Nomination Form
Anadromous Waters Catalog

Anadromous Waters Catalog Number of Water Body 111-40-10070

Name of Water Body Switzer Creek ☒ USGS Name ☐ Local Name

CORRECTION

Figure 1.—111-40-10070 route correction map.

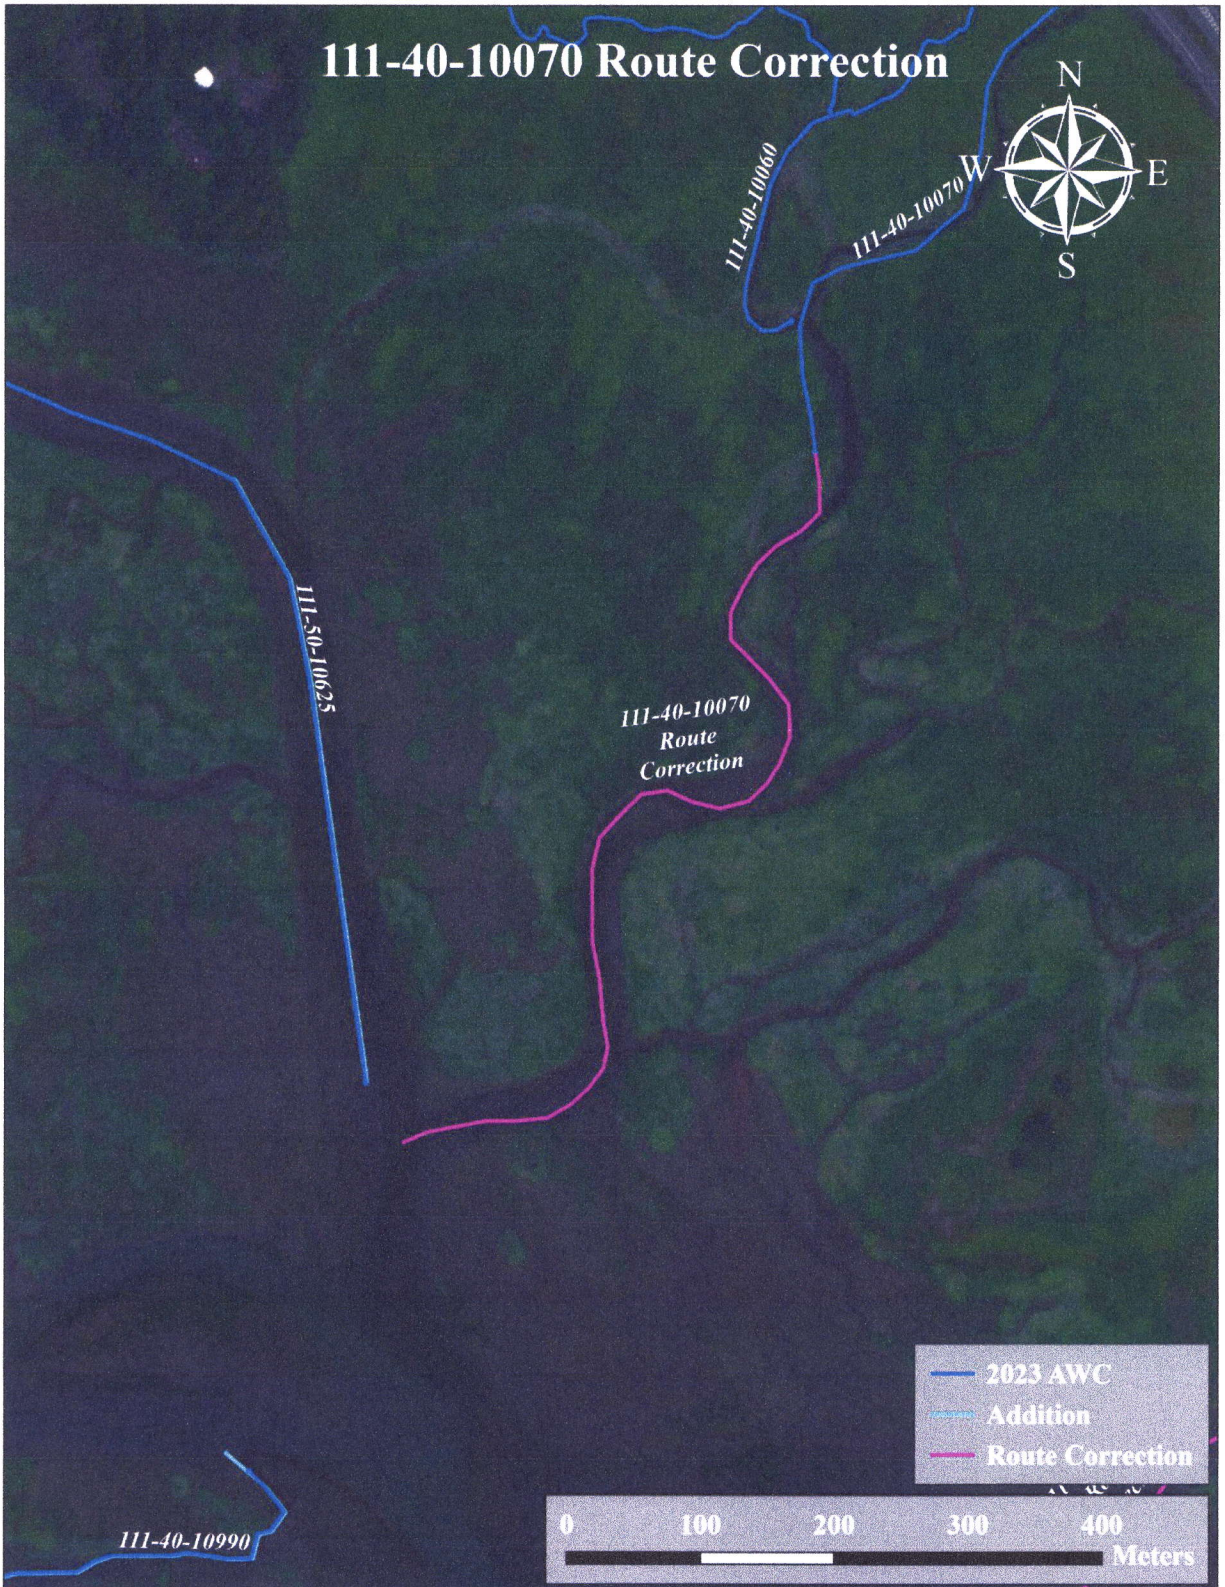
Findings: We surveyed this cataloged stream and found that the stream path is incorrectly mapped. The lower reach of the stream should be extended for clarification, particularly in light of potential alternatives identified for eventual construction of a second bridge crossing between Juneau and Douglas.

Recommendations: Correct Stream No. 111-40-10070 in the anadromous waters catalog to reflect the field verified stream path. Please extend stream into the intertidal (Figure 1).

~UPDATE/RELOCATE mouth point location of existing AWC Stream #111-40-10070 "Switzer Creek" to better approximate the location of Mean-Low-Low-Water (MLLW).

-Please update using most recent .GDB with line, point, lake, polygon and barrier features located in O:\DSF\IR5\AWC\Draft2025\GIS\DATA\AWC_2025update_WORKINGv1_day-month-yr.gdb
